CITY OF ALBUQUERQUE

Planning Department
Alan Varela, Director

**RE: 351 Manuel Sanchez Place SW
Grading and Drainage Plan
Engineer's Stamp Date: 10/12/22
Hydrology File: K12D025**

ENGINEER'S SEAL	LOT 3-P1 PUESTA DEL SOL 351 MANUEL SANCHEZ PL	DRAWN BY DEM
DAVID SOULE NEW MEXICO 14522 REGISTERED PROFESSIONAL ENGINEER	GRADING AND DRAINAGE PLAN	DATE 10-11-22
10/12/22	Rio Grande Engineering	LOT 3-P1 AND 3-P1 PUESTA DEL SOL, DWS
DAVID SOULE P.E. #14522		SHEET # C1
		JOB #

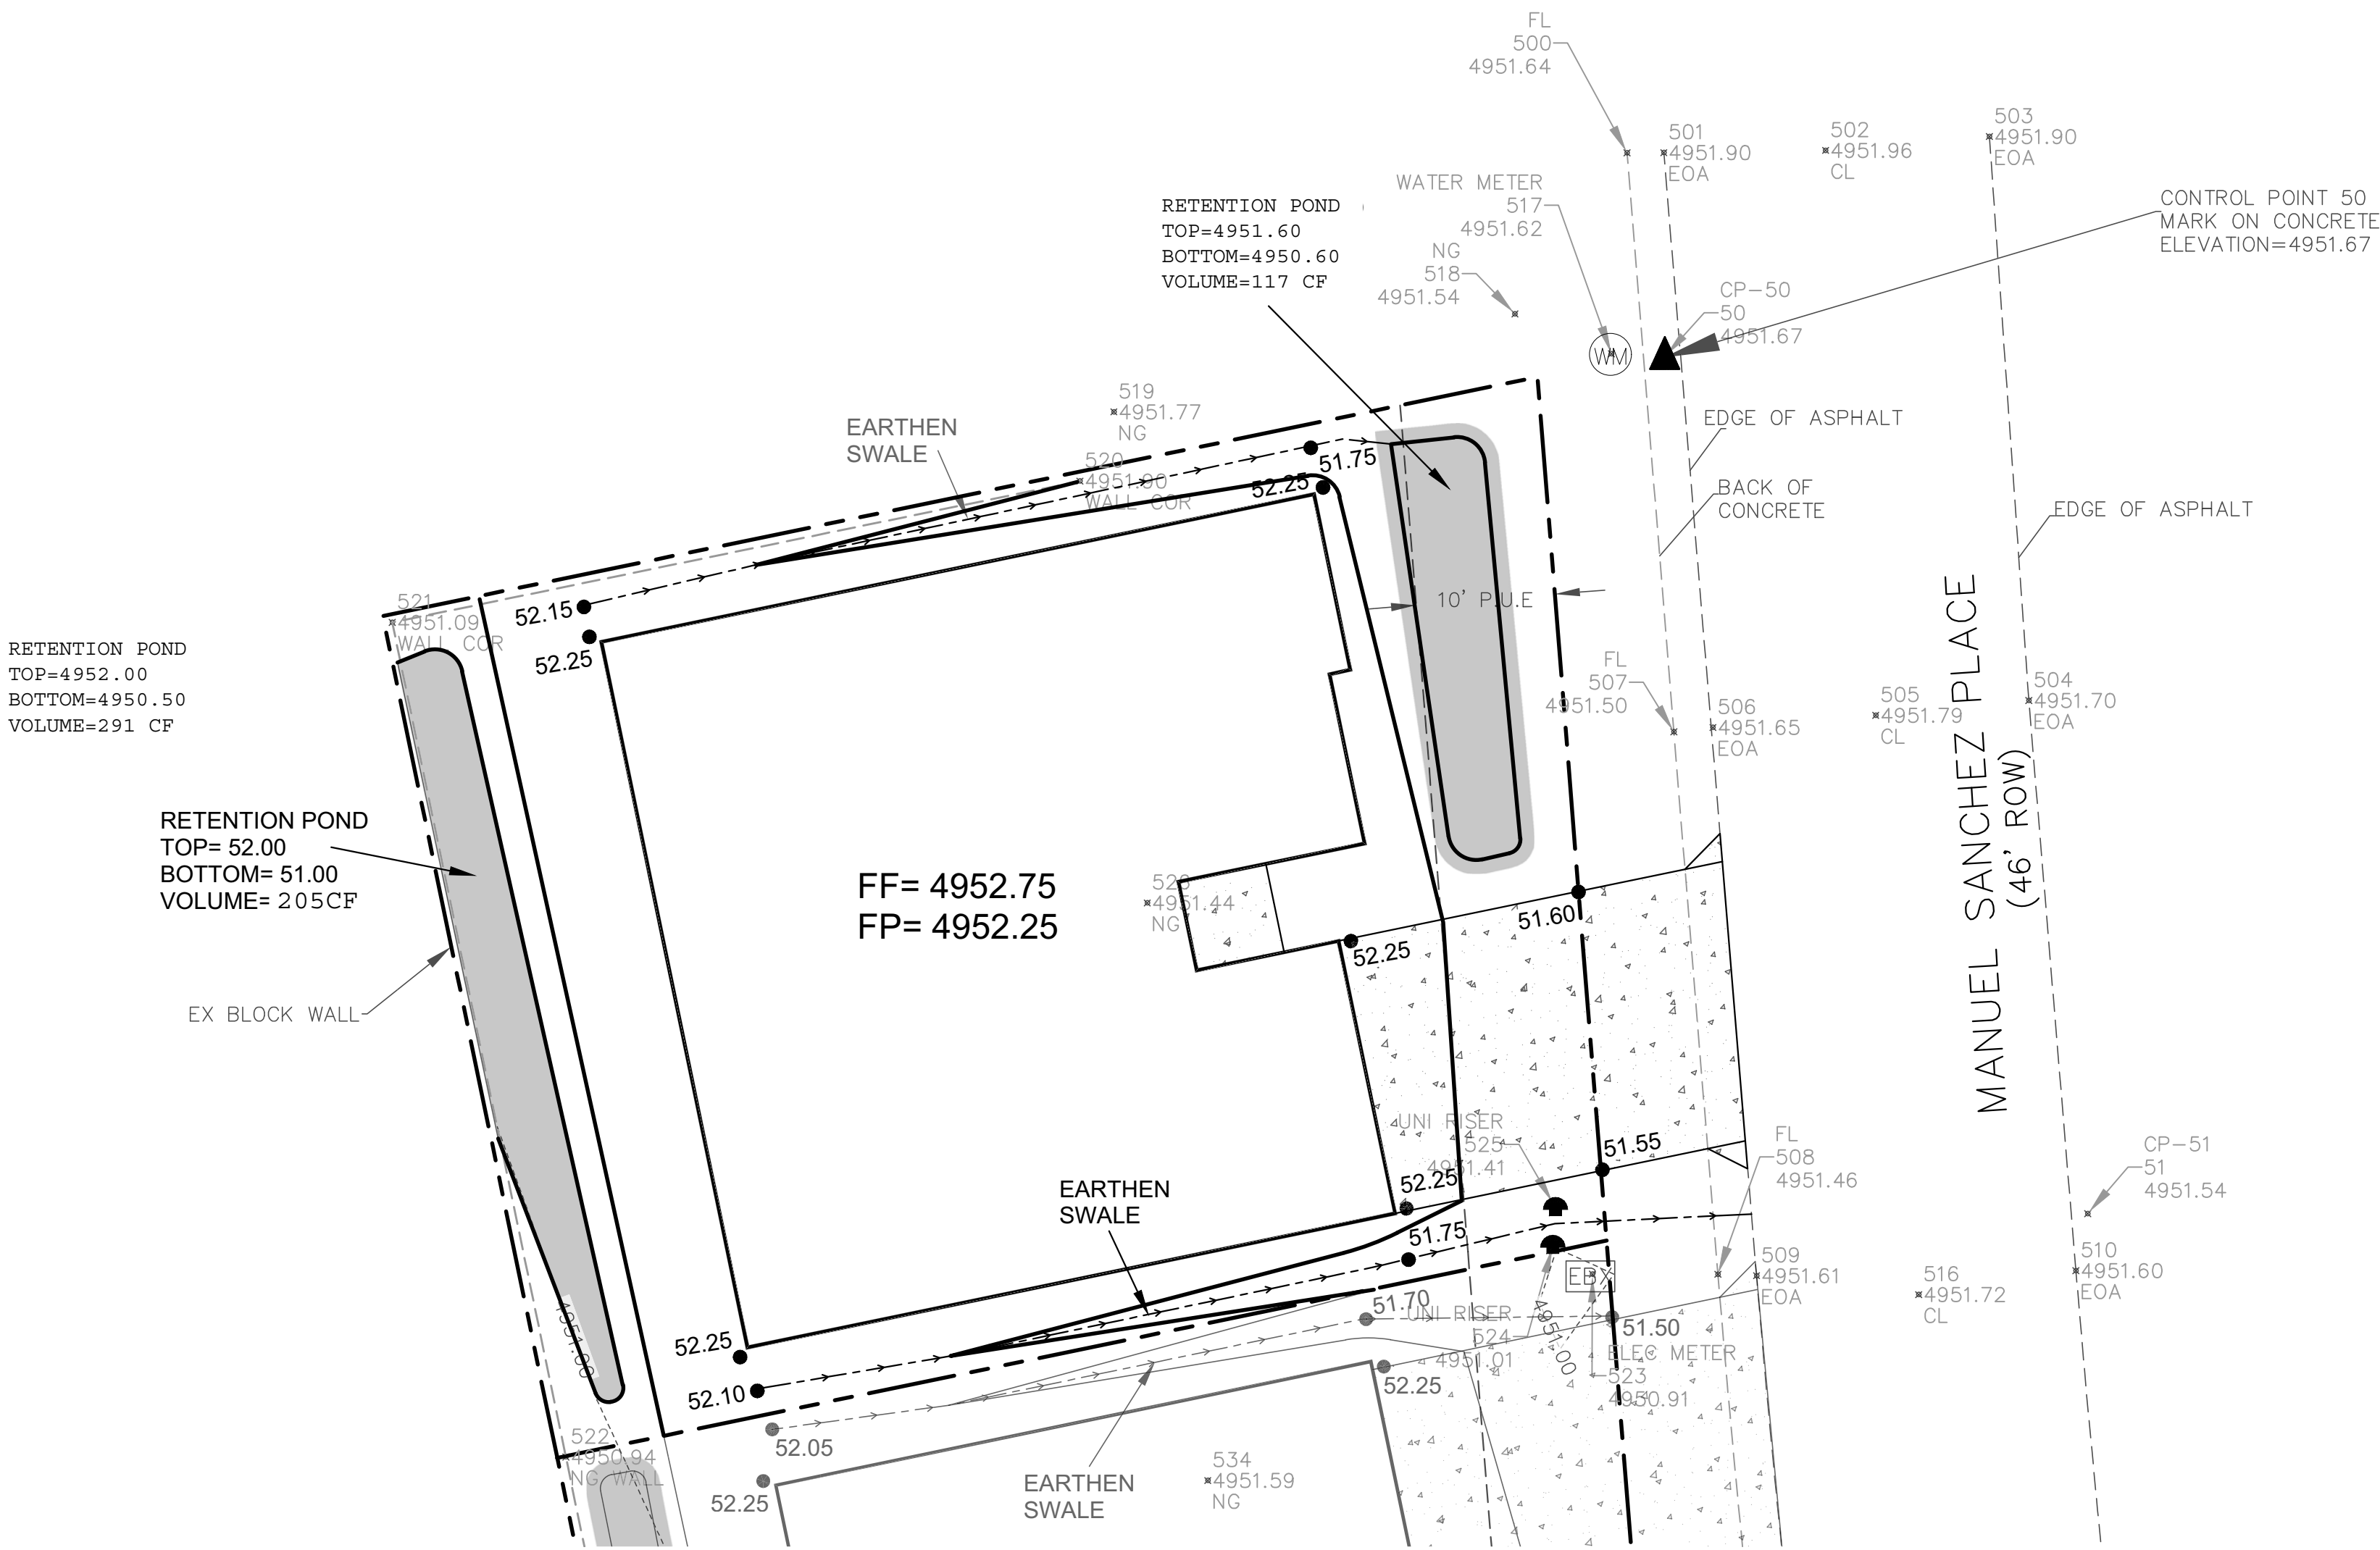
Based upon the information provided in your submittal received 10/13/2022, the Grading & Drainage Plan is approved for Grading Permit (earthwork can get started for the earth pad on the house).

1. Once the grading is complete, a pad certification (meaning that the earthwork is complete) will be required. Please include a site photo with the submittal. Also, at the time of pad certification approval, Hydrology will concurrently approve the Grading & Drainage Plan for Building Permit.
